2002	Toshiba America Consumer Products, Inc.	Date: 01/29/2002
Product	Technical Bulletin	TV0201
PJTV		Ref. No. 012902

## **TECHNICAL BULLETIN**

## **TECHNICAL BULLETIN**

# TECHNICAL BULLETIN

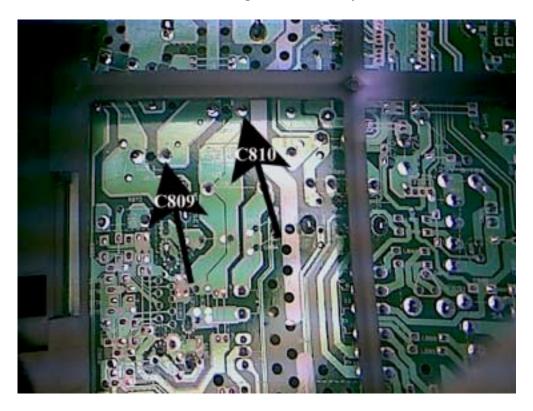
**Symptom:** Power LED lights. Power supply does not start.

Corrective Action: Check the solder connections at the negative side of both C809 and

C810. Resolder if necessary. Poor connections could possibly open fuse

F860. Check the fuse and replace if necessary.

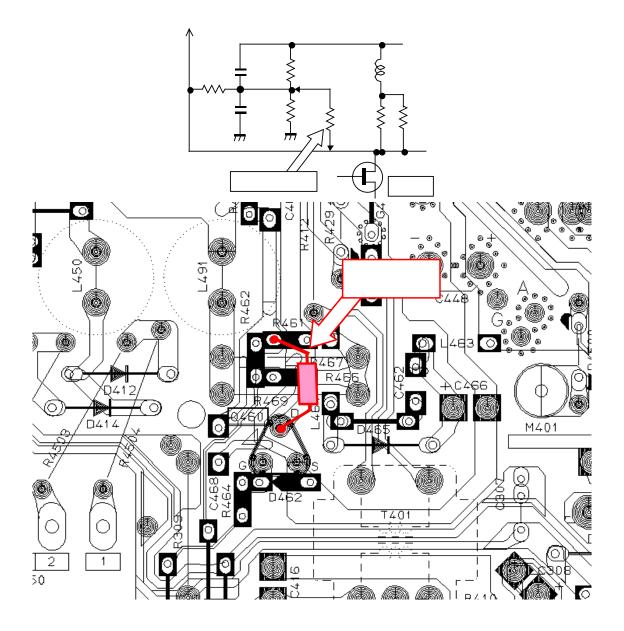
**Subject:** Stabilize Q302 feedback circuit.

**Symptom:** Vertical line bends or doubles for 2 seconds after switching on set.

Add two resisters (R463, R4703) and change one capacitor (C4693) to stabilize Q302 feedback circuit.

Location	Part Number	Description	
R463 (new)	24366473	Resistor, Carbon film,	
		47KΩ, 1/6 W	
R4703 (new)	24366331	Resistor, Carbon film,	
		330Ω, 1/6 W	
C4693 (change to)	24591473	Capacitor, Plastic film,	
		0.047 MFD, 50V

# POW/DEF board

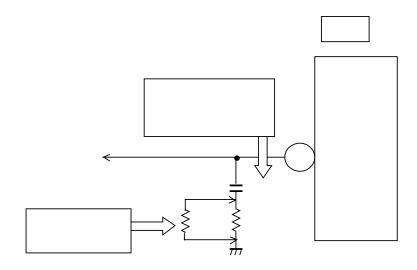
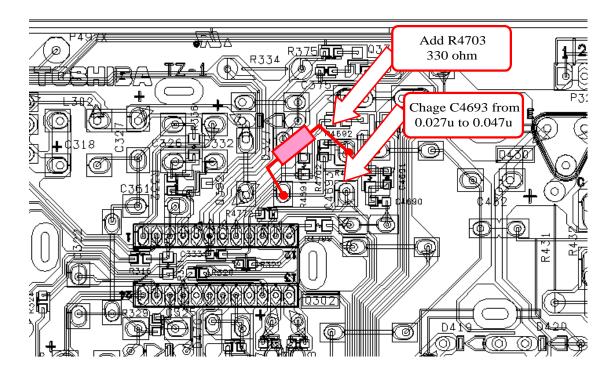
See attached illustrations.

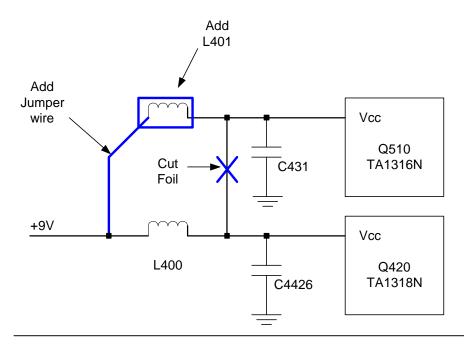
**Symptom:** Wavy vertical line when room temperature is below 32° F (0° C.)

**Corrective Action:** Add peaking coil (L401) into Vcc line of Q510 (TA1316N). Add jumper wire and cut foil pattern as shown below.

Location	Part Number	Description
L401 (New)	23280022	Coil, TRF4101AZ

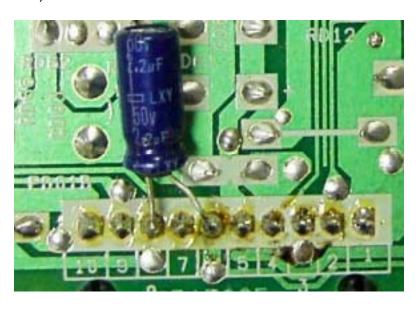
**Symptom:** Audible white noise (static hiss) at low volume levels.

Corrective Action: Add 2.2uf/50V electrolytic capacitor (PN 24617912) between Wout

(pin 6) and GND (pin 8) of PD01B on SRS3D A-Pro/SRS WOW PCB

(UD01).
